**RE:OBJECTION TO WELLINGTON GAS FIRED POWER STATION –
MP06_0315 MOD 2**

Wellington Power Station – ambient noise level monitoring results

Re: ERM's incorrect isopleth data for Wellington's proposed Gas-Fired Power Station

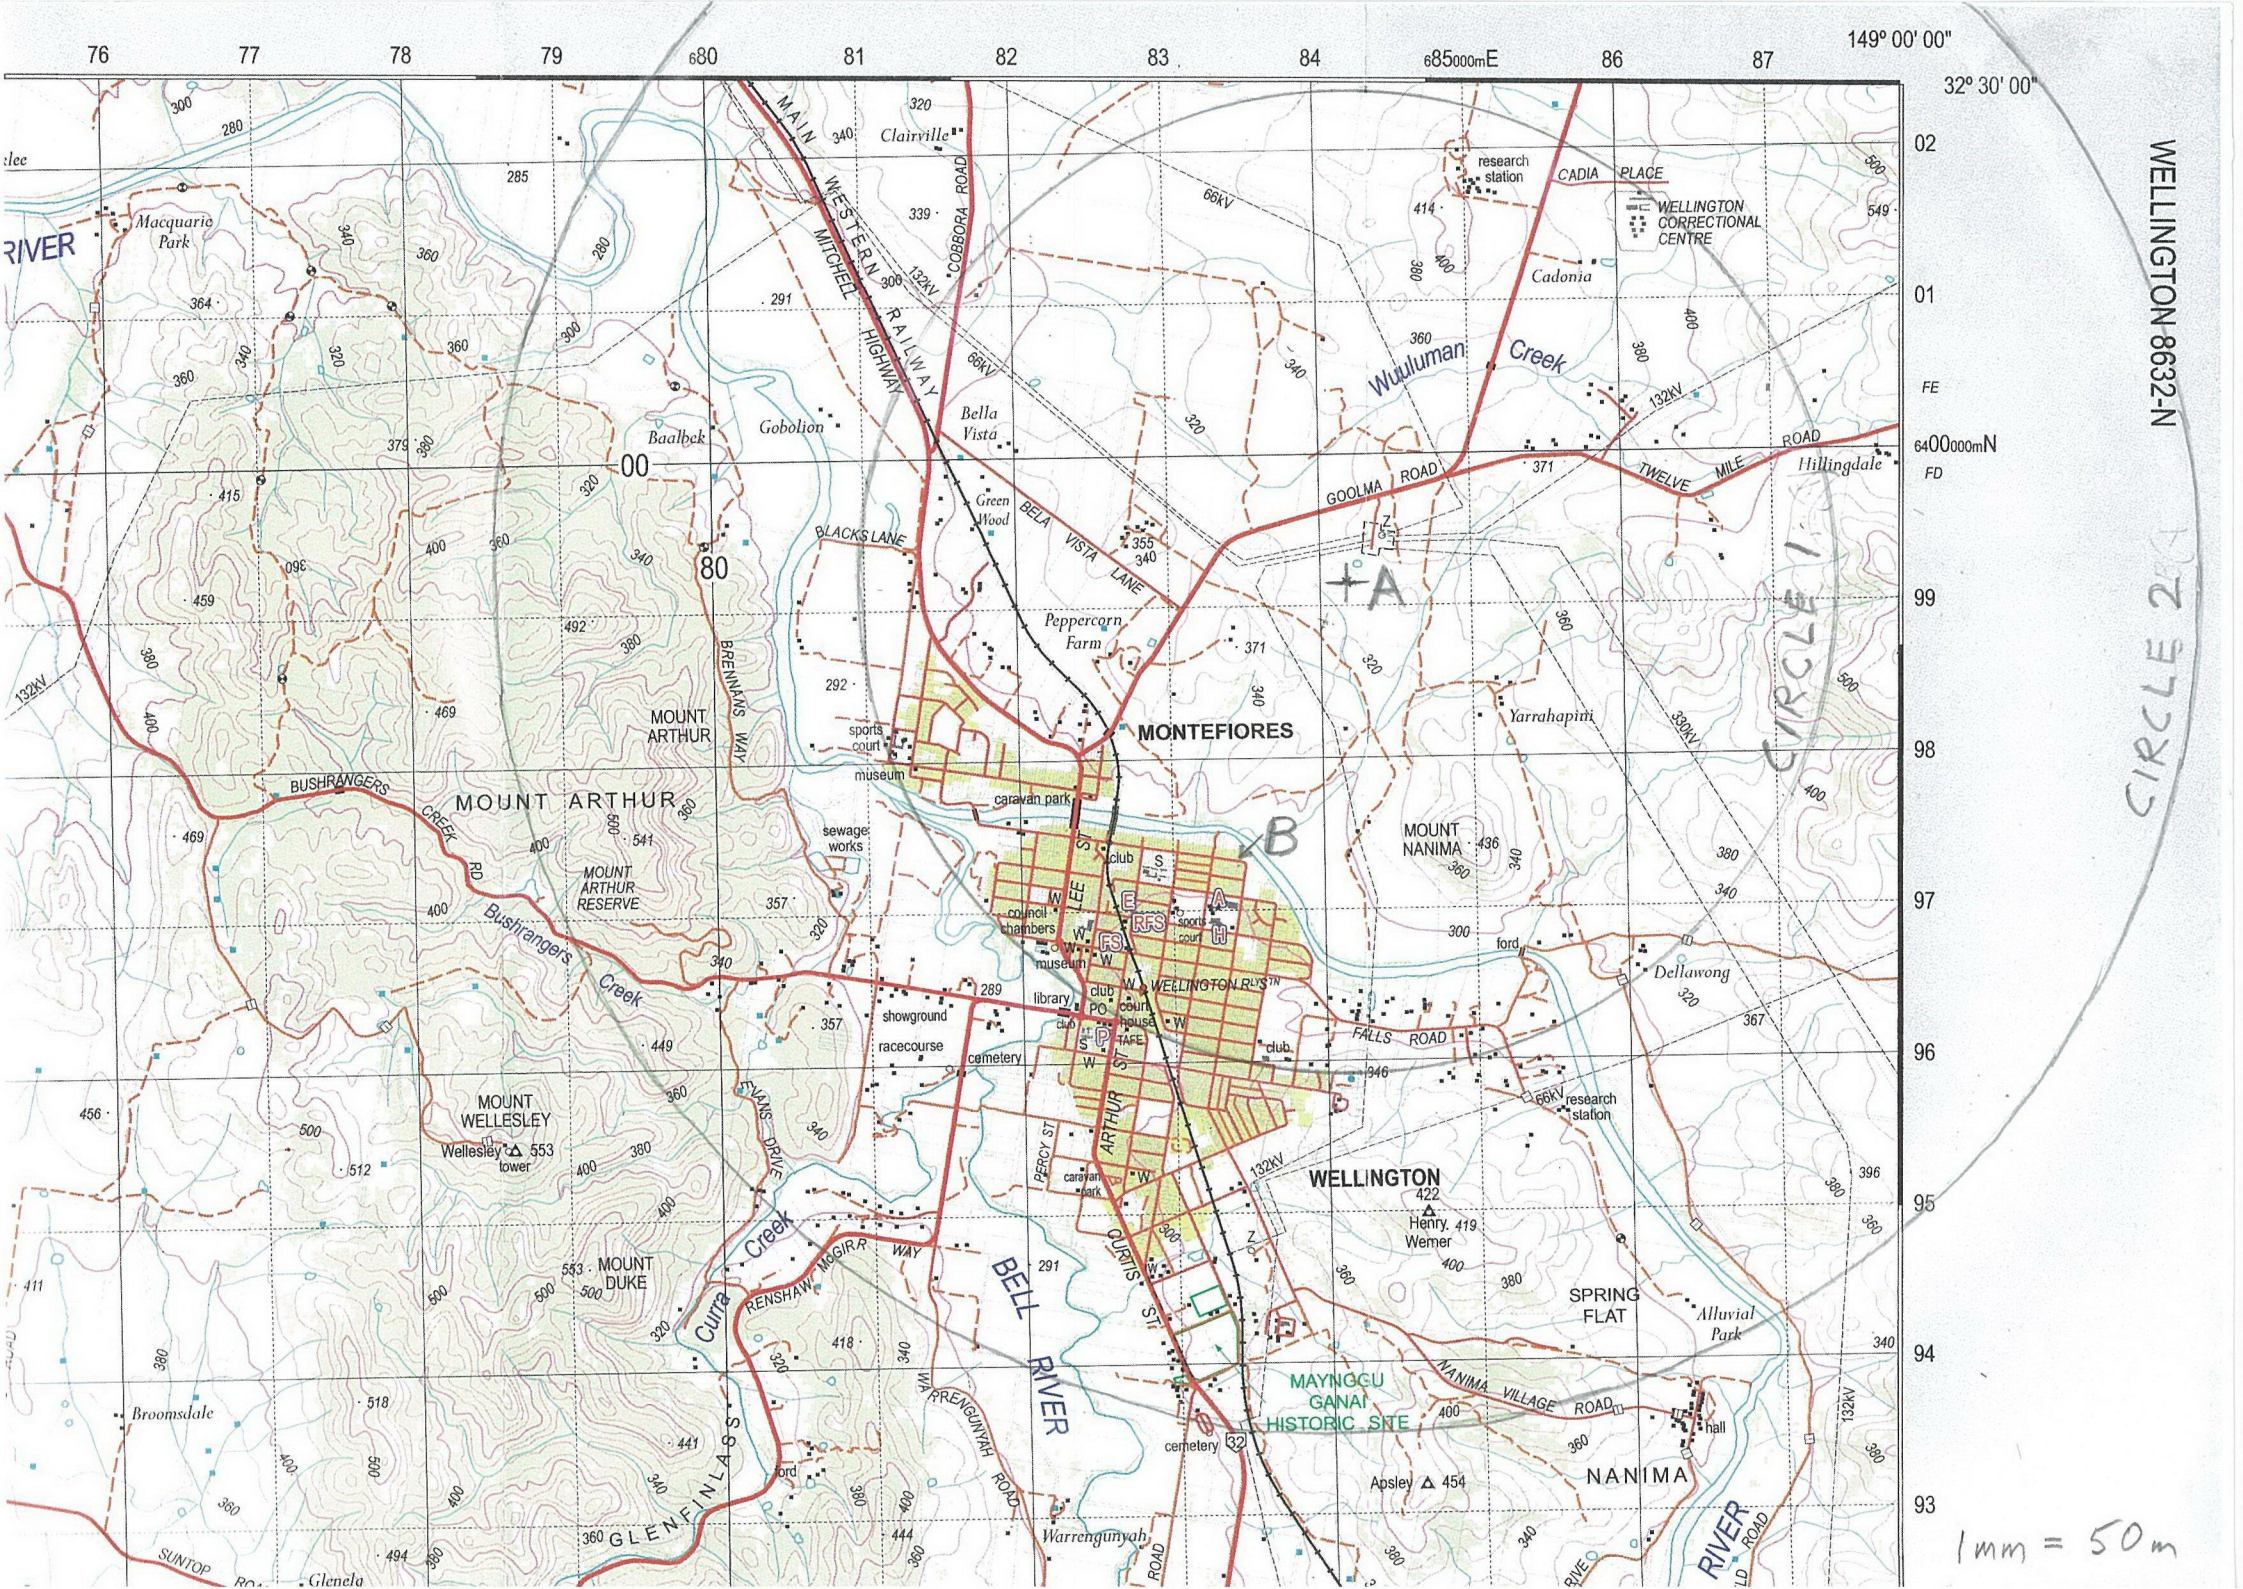
On the attached map:

Position A indicates the location of the proposed site.

Position B shows where I live.

Inside Circle 1 Offending noises may exceed the background by more than 5 dB(A).

Inside Circle 2 In my opinion, offending tonal noises could be audible, as tonal noises can be heard below the background, hence the penalty. Older people, having lost the masking effect of the higher frequencies, could hear tonal low frequencies relatively louder, making the annoyance worse to them.

Please, look at Circle 1 carefully. There may be serious noise consequences anywhere inside it.

Figure 9-7 Predicted noise impact isopleth (neutral conditions with +5 dBA low frequency modifying correction factor) for the power station and surrounding environment

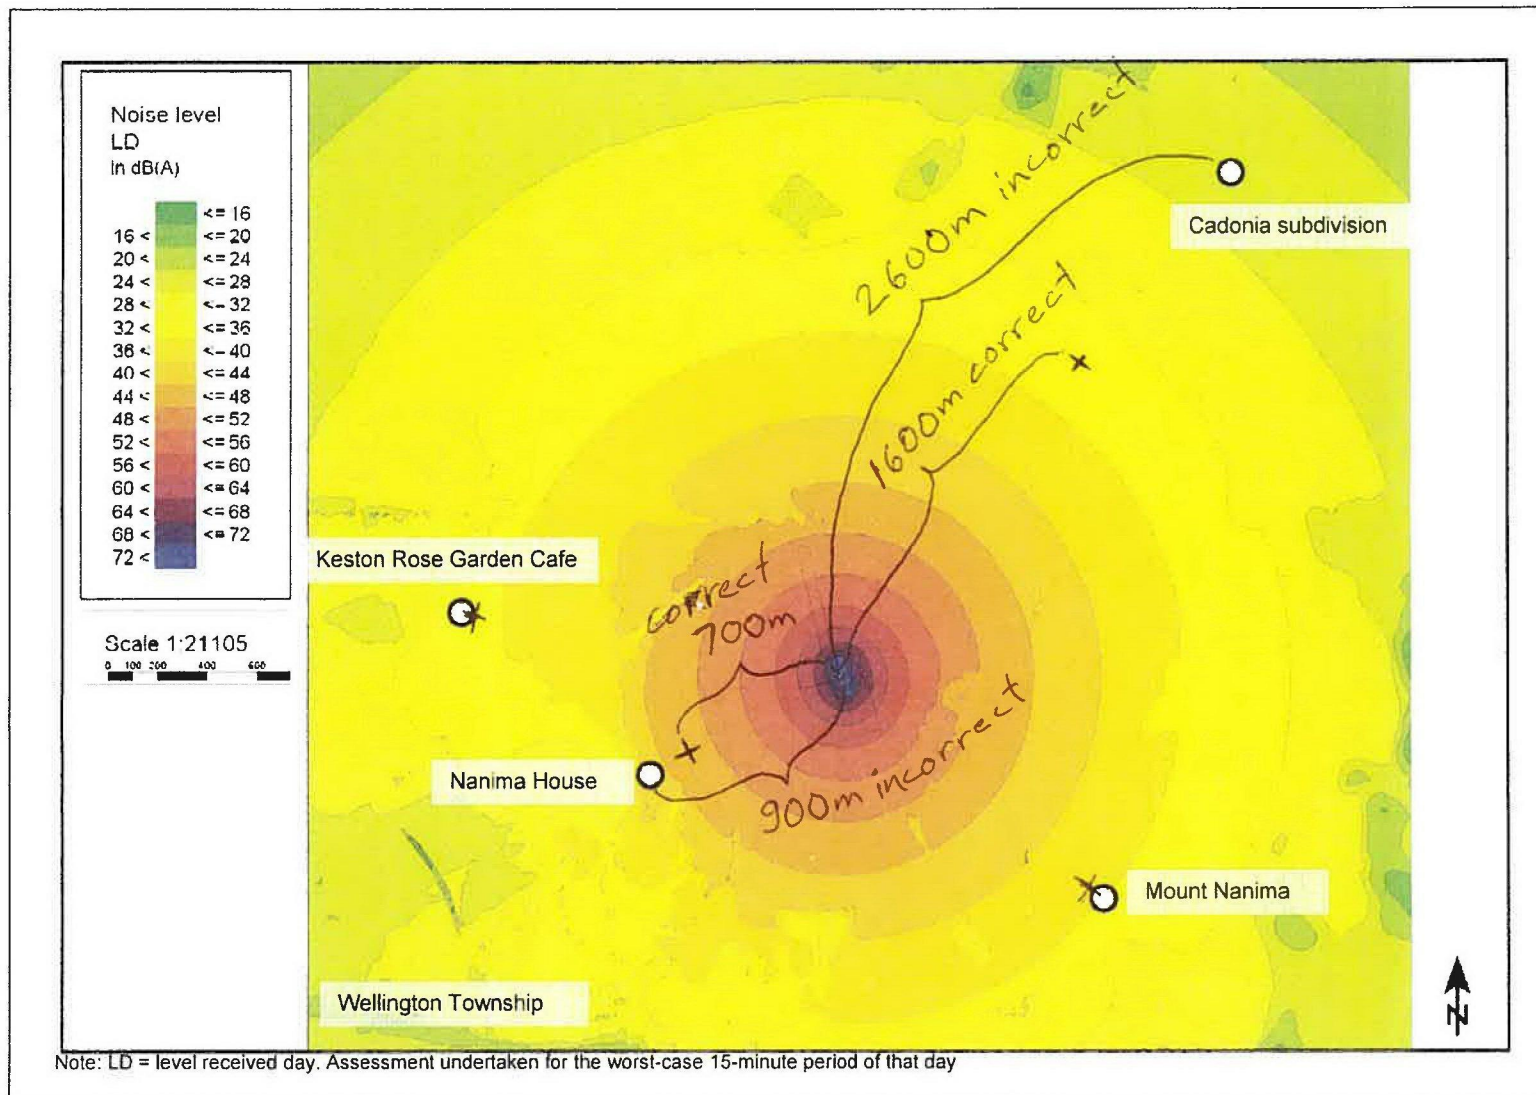
This time please see attached Figure 9-7 from the Environmental Assessment ("EA"). This isopleth is the source of the original incorrect data, from which most of the subsequent incorrect data is produced. This original **incorrect** data has been used as reference, from which the so called "improvements" have been deducted.

The noise impact isopleth shows that Cadonia subdivision is in a wrong location approximately 2600m from the sound source, instead the **correct** distance of 1600m. There are two symmetrical sections of the rings of 4dB(A), each of which increase the Original configuration noise level from 26.5dB(A) to 34.5dB(A). I wonder if Parsons Brinkerhoff ("PB") was confused with the nearby located Jail, the Wellington Correctional Facility, that is close to the designated location of the Cadonia subdivision. No doubt the **undisclosed** infrasound will reverberate inside the cells, causing serious health problems such as cardiovascular disease, severe depression and anxiety, and immunosuppression resulting in serious chronic infections and cancers. These serious **predictable** health problems will result from chronic sleep deprivation and chronic psychological stress, in some of the long term inmates. They will be unable to escape to protect themselves.

Unfortunately ERM's incorrect scaling of the distance for the Cadonia Subdivision wastes so much area on top of the isopleth, that the entire Wellington Township has been left out at the bottom of the isopleth. I have included the location of Council Chambers for reference. Perhaps this was a deliberate omission??

The other important incorrect location on the isopleth is Nanima House, which is shown approximately 900m from the sound source instead of the correct distance of 700m. The symmetrical section of the ring of 4dB(A) increasing the original condition noise level from 43dB(A) to 47dB(A).

Therefore ERM's first claim that the MOD1 offending noise at Nanima House inside the noise barrier is 35dB(A) has failed as $47 - 8$ (noise barrier reduction) = 39dB(A). This is clearly noisier than the Compliance goal 35dB(A).

ERM's second claim that the proposed 2 turbine noise of MOD2 at Nanima House is less than 40dB(A) has also failed, as $47 - 5$ (improvement due to "quieter" turbines being only 5dB(A) instead of incorrectly claimed 7dB(A) = 42dB(A), resulting in forced acquirement of heritage listed house. This error was pointed out to you in my "fruit salad" letter of 27 April 2015.
